Technical Bulletins

TECHNICAL BULLETIN

MODEL/DERIVATIVE:
MINI

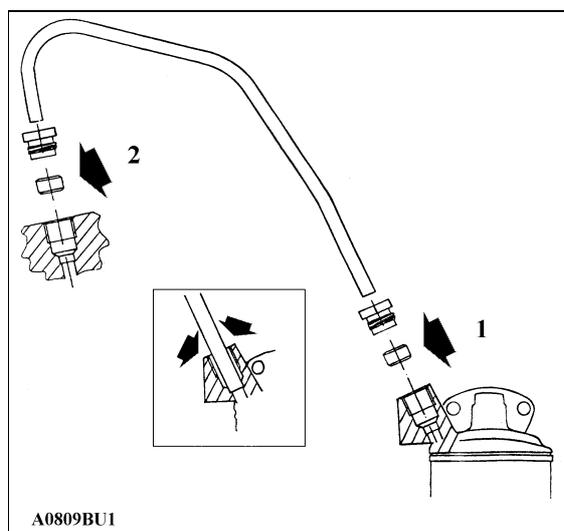
PROBLEM:
OIL LEAK FROM EXTERNAL OIL PIPE CONNECTION - OLIVE

Oil leaking from external oil pipe to cylinder block via tube nut connection.

CAUSE:
Torque relaxation of tube nut

Remove external oil pipe completely, dismantle to retrieve tube nuts, discard pipe and both rubber seals.

Completely clean cylinder block, filter housing and tube nut mating threads.

Assemble new pipe part number LQP10033 and original tube nuts with new rubber seal part number LZB10017 to filter end (1 in illustration), and modified aluminium olive part number LZV100080 to cylinder block end, (2 in illustration).

Fit oil pipe to block and oil filter housing, ensure pipe is fully inserted into cavity recesses (see illustration inset), engage tube nut threads and apply "Loctite Lock'N Seal 242" to exposed threads and tighten tube nuts by hand alternating 1/4 turn at a time so as to avoid over stressing pipe in any one direction.

Finally tighten each tube nut with a suitable open ended spanner .

When tight, the underside of the tube nut at the filter head end will make contact with housing, unlike the block end which is now prevented from making contact with block face due to the aluminium olive which does not compress.

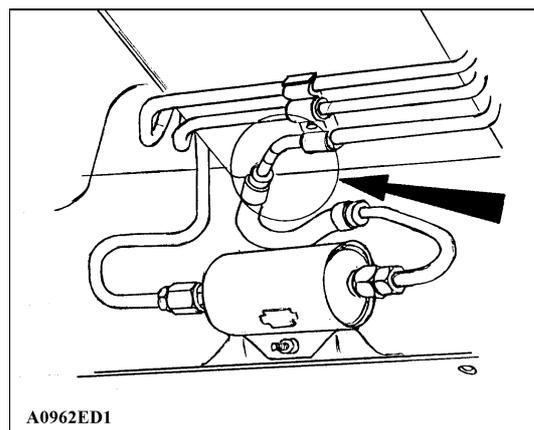
PROBLEM:
ENGINE NON START / FUEL PUMP NOISE - PIPE DAMAGE

CAUSE:
Bent under floor fuel feed pipe particularly in area illustrated. This may result in the flexible fuel feed hose being kinked causing local fuel pressure build-up.

ACTION:
Carefully re-shape fuel feed pipe so that flexible hose returns to correct position.

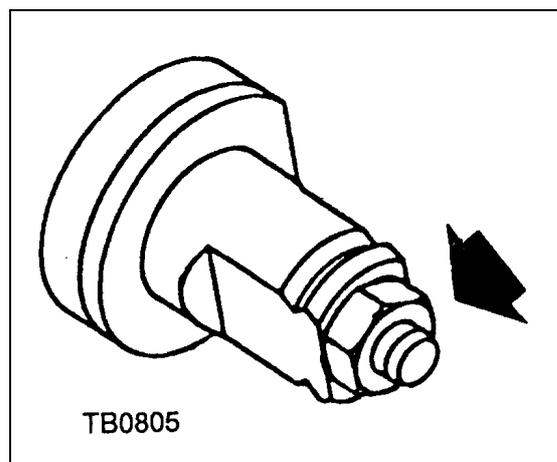
SEAT SQUAB 'CREEP BACK' - RECLINER NUT

Torque relaxation of recliner mechanism nut.

Remove recliner hand wheel to expose the die casting and M4 nut (see illustration.

Hold die casting with an 8mm spanner across the flats and tighten the M4 nut a quarter of a turn (one and a half flats).

check operation of recliner, if OK apply Loctite 924 or 638 to end of nut / thread. Refit hand wheel.

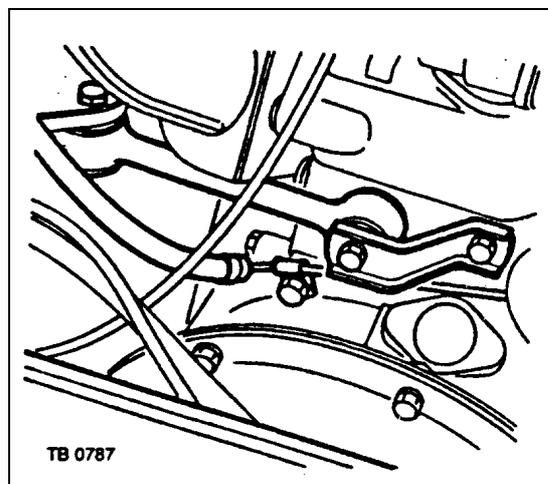
PROBLEM:
ENGINE SHUNT - WEAK STEADY BAR BUSHES

CAUSE:
Upper engine steady bar bushes providing insufficient damping

ACTION:
Replace existing bushes with heavy duty bushes.

PARTS INFORMATION:
KKF100390 - Bush Engine Steady (heavy duty) - 4 off

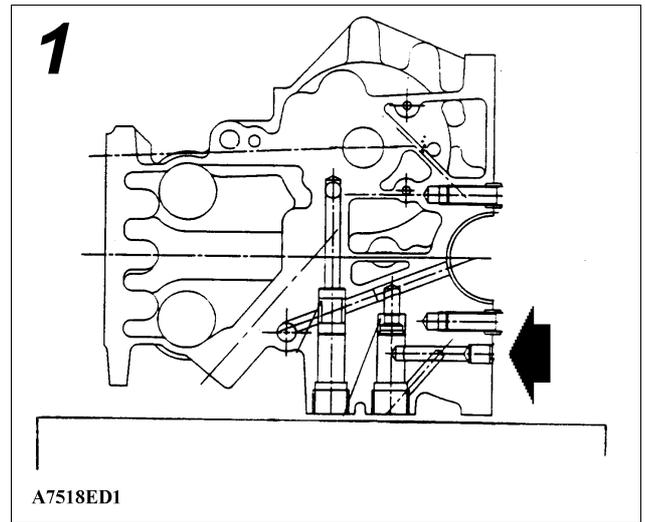
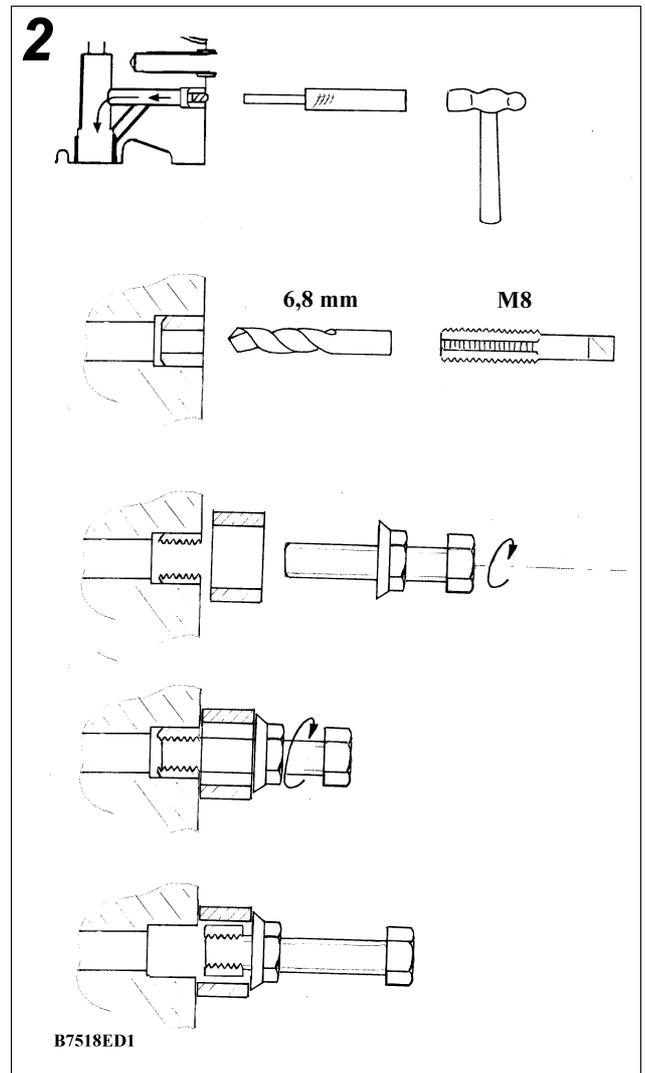
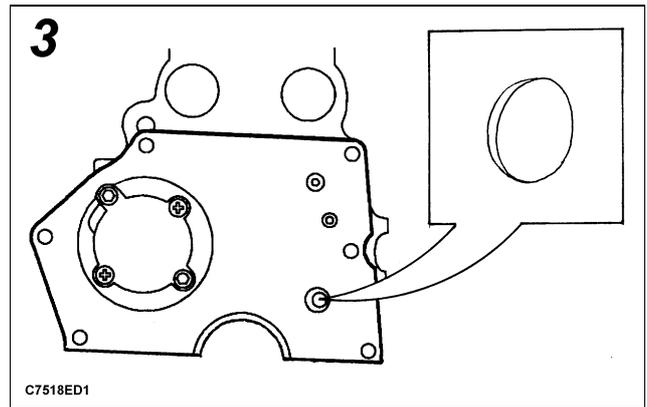
Condition is caused by a recent modification to the relief valve drain exit drilling in the cylinder block.

- **Remove oil sealing plug from the relief valve drain drilling at the sump face.**
- **Plug existing 'angled' relief valve drilling at the block rear end face.**

- Locate the oil sealing plug (arrowed in illustration 1) situated adjacent to the rear main bearing cap. The plug outer is aluminium and the centre core made from steel.
- Using a suitable flat ended punch (illustration 2), gently tap the steel core of the plug until level with the aluminium plug body.

- Using a smaller punch (3 mm dia), tap the plug centre core completely through, it should drop clear from the relief valve hole and onto the bench, if it doesn't, lift the engine slightly and retrieve with a magnet.

- Locate the oil drilling in the end face of the cylinder block (arrowed), this is a large shallow countersunk drilling leading into a smaller hole.

- Obtain tapered plug, part number LCM 100140. Apply a bead of Loctite 638 around the taper portion of plug and tap securely into the position shown.
- Wipe off any surplus Loctite and clean excessive oil from primary gear, flywheel and flywheel housing before re-assembly.
- Rebuild engine observing correct torque figures etc.

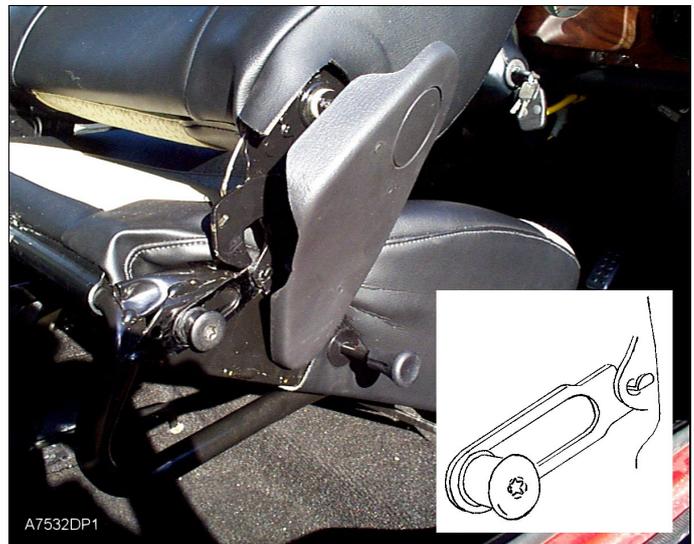
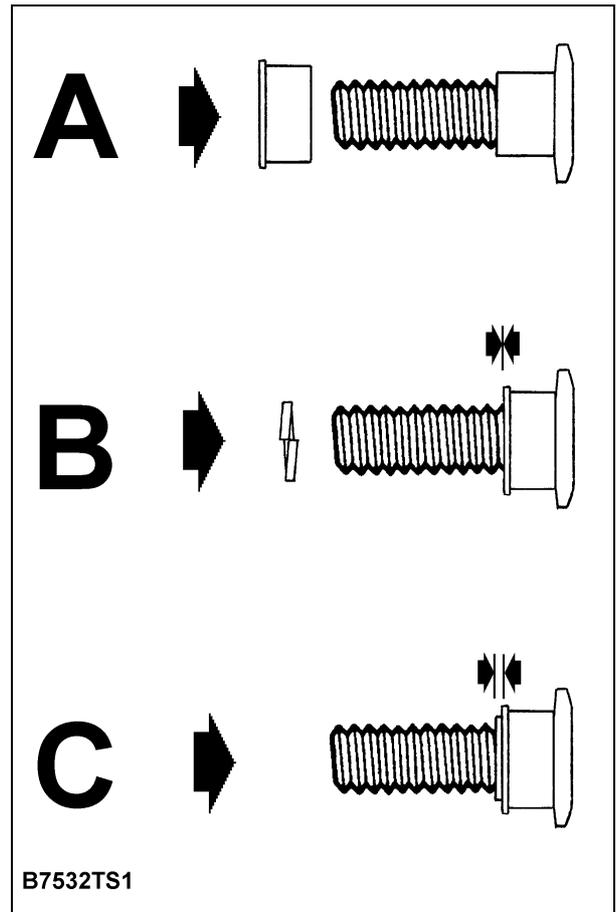
PROBLEM:
SEAT CUSHION DAMAGED - UNRESTRAINED TIPPING

ACTION:
The damaged seat cushion cover(s) will require replacement.
To prevent re-occurrence of seat cover damage, fit two check straps per seat part number HZU 100050.
This modification should be applied to both front seats even if opposite seat has not sustained damage requiring cover replacement.
All vehicles from Vin 151917 onwards have check straps fitted.

1. Carefully disengage the rear escutcheon fixing from one seat side to expose hinge.
Note: try not to bend escutcheon excessively as this may break plastic fixings or bruise the outer escutcheon surface.
2. Remove the black Torx 50 squab striker and plastic sleeve. If a flat washer is also fitted retain this for re-fitment.
3. Reverse the sleeve position on striker so that sleeve flange is now adjacent to thread (illustration 'A').

4. View sleeve end in relation to striker shoulder. If flush with shoulder (illustration B), fit a suitable size spring washer to provide a shoulder extension, 'see parts information'. If shoulder protrudes slightly (illustration 'C'), no spring washer is required.
5. Fit check strap by hooking tab into redundant hole position in hinge (see photo inset).
6. Re-fit and tighten striker bolt so that the exposed striker shoulder or spring washer locates check strap slot. If a flat washer was originally fitted, refit between check strap and seat frame.
7. Re-fit escutcheon rear fixing.
8. Repeat modification for opposite side of seat.
9. Ensure that squab tips satisfactorily and that seat locks securely in upright position.

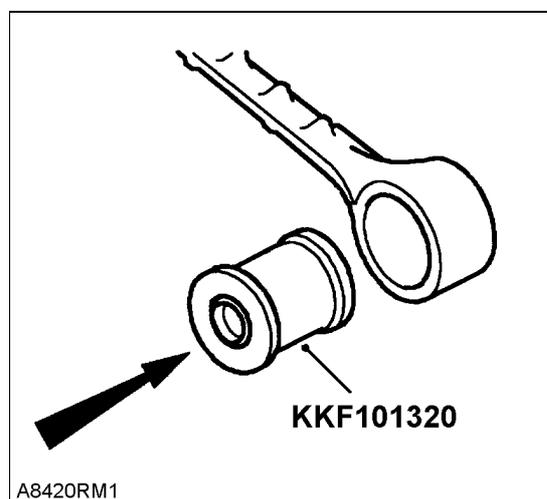
ENGINE STEADY BUSHES WEAK - MODIFICATION

To increase upper engine steady bush durability, replace the 2 upper rubber bushes for single bush part number KKF101320.

***NOTE:* This bush cannot be used on the lower tie bar. This is due to the fixing bolt being a different size to the upper.**

1. Remove upper engine steady from vehicle and remove worn bushes and spacer tube from steady.

2. Press new single bush KKF101320 complete with bonded internal spacer tube into engine steady. To assist fitment, the new single bush assembly can be pushed into steady with the help of a vice and a suitable spacing tube such as a socket, (there is no special tool available for this purpose).

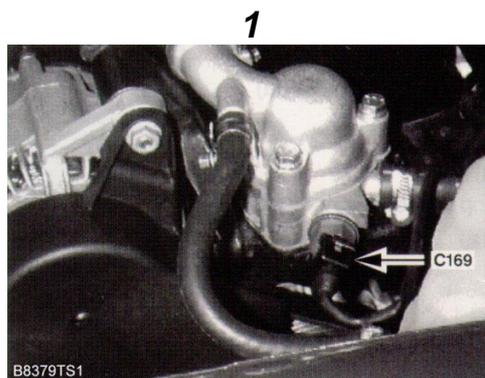
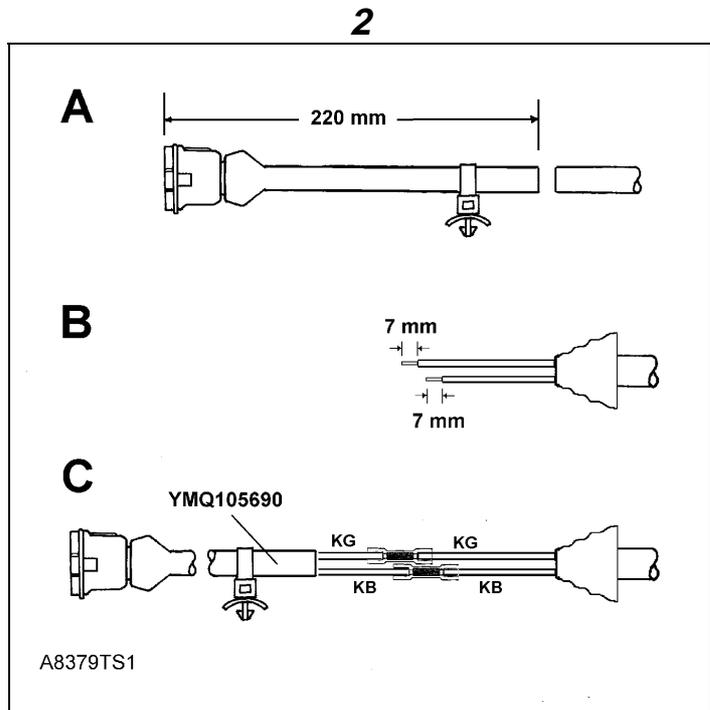
PROBLEM:
COOLING FAN RUNS CONTINUOUSLY – TEMPERATURE SENSOR

ACTION:
A service fly-lead with modified sensor connector is now available. This part can be fitted by following the instruction provided below.

1. Ensure radio code is available and disconnect battery negative terminal.
2. Disconnect connector C169 from the coolant temperature sensor (see illustration 1).
3. Disconnect the sensor lead securing clip from the coolant expansion tank bracket.
4. Referring to illustration 2A, measure approximately 220mm back from the connector, then cut through and discard this section of lead.
5. From the cut end of the remaining lead section, peel back approximately 50mm of the outer protective sheathing and stagger cut the wires. Strip approximately 7mm of insulation from each wire (see illustration 2B).
6. Ensuring correct wire colour matching, connect new service link lead YMQ105690 to each harness wire using Duraseal type connectors (see illustration 2C).

7. Re-position protective sheathing to cover Duraseal connectors.
8. Secure new lead to expansion tank bracket with the attached plastic clip.
9. Fit the new lead to temperature sensor ensuring connector is correctly latched.
10. Re-connect battery and enter radio code.
11. Before returning vehicle to owner, turn ignition on and confirm that cooling fan is not running.

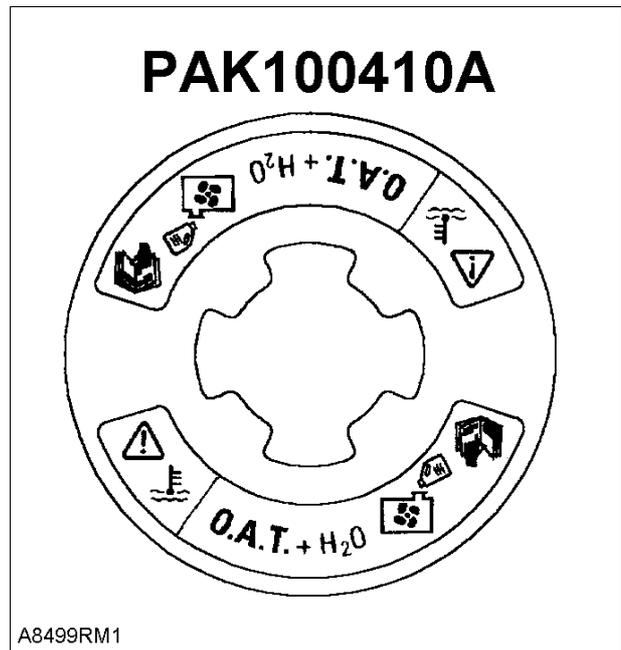
COOLANT - CHANGE TO SPECIFICATION

When Unipart OAT (XLC) coolant has been added to such a vehicle it will be necessary to replace the existing black filler neck label with the OAT warning label coloured yellow, part number PAK100410A (see illustration). This will indicate that coolant specification has been changed.
